Project: IEEE P802.15 Working Group for Wireless Personal Area Networks (WPANs)

Submission Title: [Comment resolution related to Annex F in D6]

Re: [Response to the SB 1st recirculation for the IEEE 802.15.7 standard]

Comment resolution related to Annex F in D6

Figure F.4—Typical Si photo-detector wavelength sensitivity

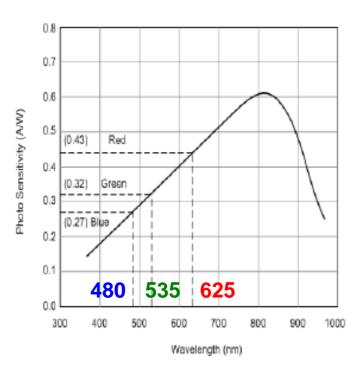
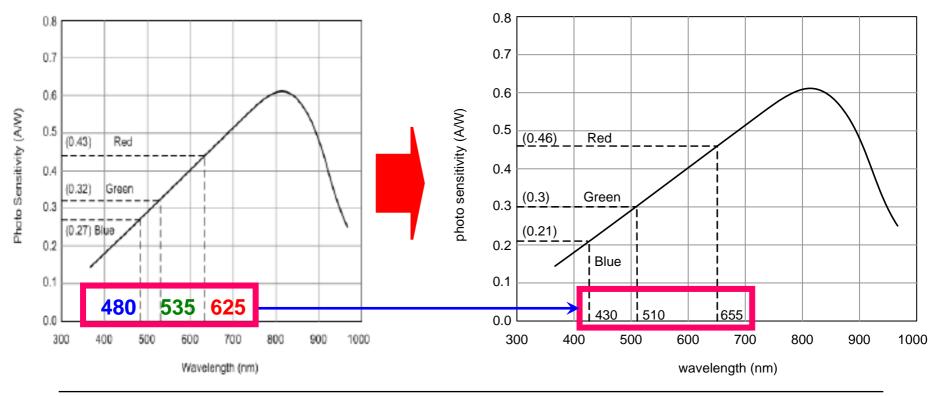
Comment No.	Name	Page	Subclause	Line	Comment	Proposed Change
21	Lim, Sang- Kyu	281	Annex F	36	Table F.1	Remake the Table F.1 as per the updated bandplan.
22	Lim, Sang- Kyu	282	Annex F	45	Table F.2	Remake the Table F.2 as per the updated bandplan.
23	Lim, Sang- Kyu	282	Annex F	40	Figure F.4	Redraw the Figure F.4 as per the updated bandplan and the updated Table F.2.
24	Lim, Sang- Kyu	282	Annex F	11	According to the updated band plan in Table 75 (page 213), 480nm, 535nm, and 625nm are not center wavelengths in 7 color bands any longer.	Change "480nm, 535nm, and 625nm" to the center wavelengths in the updated 7 color bands.

Figure F.4 and 1st paragraph on page 282

Figure F.4 shows the photo sensitivity characteristics of a Si photo-detector according to the wavelength variation. It has been known that the photo sensitivity value of Si photo-detector is higher on longer wavelength than on shorter wavelength in the visible band as shown in Figure F.4. Figure F.4 shows that a Si photo-detector produce more electrical current on red color channel than on green or blue color channel even though the radiometric received powers on each color channel are equal.

Figure F.4 should be changed as per the updated Table F.1.
